HEARING DATE: May 23, 2023

TO: Mayor & City Council

SUBJECT: Crowley Park Subdivision
H-2023-0006

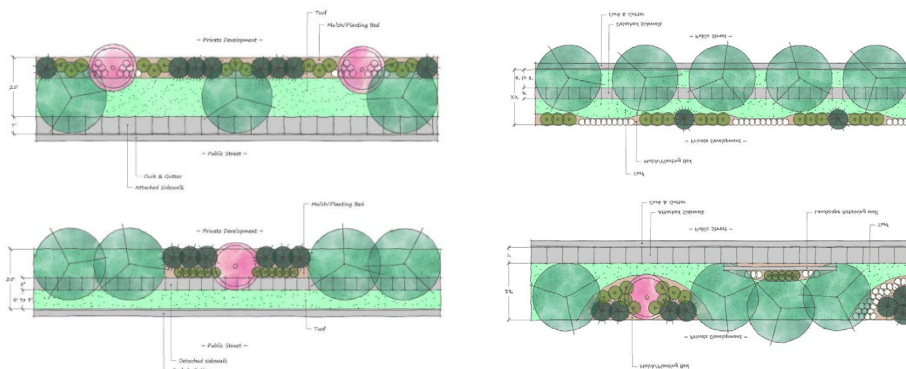
Common Driveways (UDC 11-6C-3D): Common driveways shall serve a maximum of four (4) dwelling units. In no case shall more than three (3) dwelling units be located on one (1) side of the

driveway. The Applicant is proposing five (5) dwelling units take access off the common driveway, all five (5) dwelling units are also located on one (1) side of the driveway. *Per UDC 11-6C-3D.9, the Director may approve or recommend approval of alternative design or construction standards when the applicant can demonstrate that the proposed overall design meets or exceeds the intent of the required standards of this section and shall not be detrimental to the public health, safety, and welfare.*

Alternative Compliance (ALT) to the common driveway standards is requested due to the lot only having access from an arterial roadway; there is no local street connection available to this site. Staff recommended this site layout to allow for more usable backyards for the southernmost lots, as the south boundary is encumbered by an irrigation easement. Based on the analysis, the Director is supportive of the request for ALT for the proposed five (5) dwelling units taking access off the west side of the common driveway.

C. Landscape Plan (dated: 1/23/23) – NOT APPROVED (NEEDS TO BE REVISED)

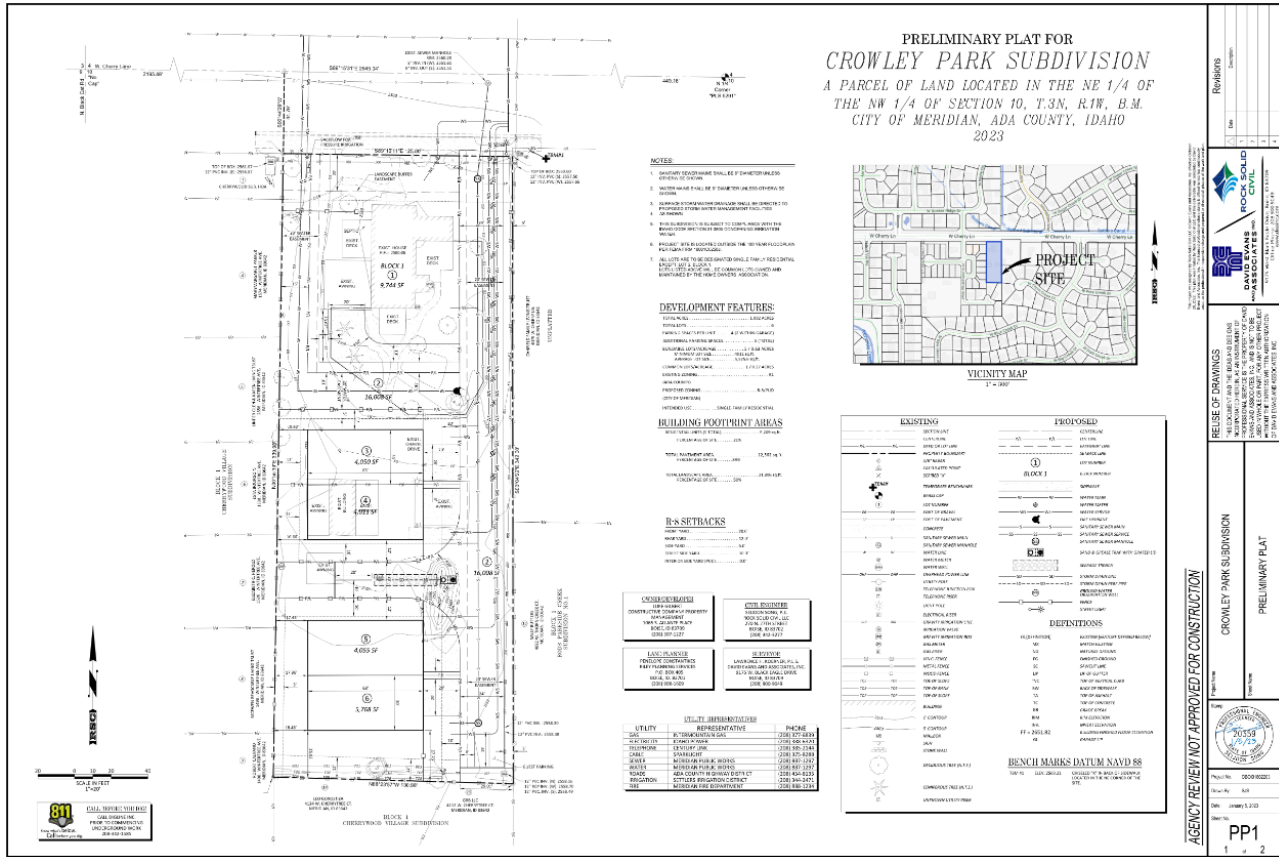
Landscaping (UDC 11-3B): A twenty-five foot landscape buffer is required along W. Cherry Lane in accord with UDC 11-3B-7. The landscape plan submitted depicts a 20-foot landscape buffer along W. Cherry Lane that includes four (4) existing trees. *Per UDC 11-3B-7C.1(c), in a development where the required street buffer width results in an otherwise unavoidable hardship to the property, a written request for a buffer reduction may be submitted through the alternative compliance process. The request shall demonstrate evidence of the unique hardship caused by the required street buffer and propose a specific alternative landscape plan that meets or exceeds the intent of the required buffer. In no case shall the width be reduced to less than ten (10) percent of the depth of the lot. A reduction to the buffer width shall not affect building setbacks; all structures shall be set back from the property line a minimum of the buffer width required in the applicable zoning district.*

Alternative Compliance (ALT) to the landscape buffer width is requested due to the front porch on the existing home encroaching more than two feet into the required Landscape buffer; however, Staff recommends that the Applicant modify the plans to include the required 25-foot landscape buffer around the front porch. The landscape plan submitted does not depict an alternative means of mitigating the encroachment of the porch into the required landscape buffer. Staff recommends the Applicant add additional landscaping for mitigation as well as meet the requirements for the buffer landscaping materials. Per UDC 11-3B-7C.3, all required landscape buffers along streets shall be designed and planted with a variety of trees, shrubs, lawn, or other vegetative ground cover. Plant materials in conjunction with site design shall elicit design principles including rhythm, repetition, balance, and focal elements (see figures below).

Based on the analysis, the Director is supportive of the request for ALT with Staff's recommendation to modify the plans to include the required 25-foot landscape buffer meandering around the front porch and adding additional landscaping for mitigation to meet the requirements for the buffer landscaping materials in accord with UDC 11-3B-7C.3. The landscape plan should be revised with the final plat application.

~~3. The landscape plan submitted with the final plat shall include the following revisions:~~

~~a. Revise the landscape plan to include a 25-foot easement meandering around the front porch of the existing home for the proposed common lot adjacent to W. Cherry Lane.~~

~~b. Revise the landscape plan to depict a variety of trees, shrubs, lawn, or other vegetative ground cover in the landscape buffer along W. Cherry Lane per UDC 11-3B-7C.3.~~

~~c. Depict a fencing detail for all new fencing proposed for the subject site.~~
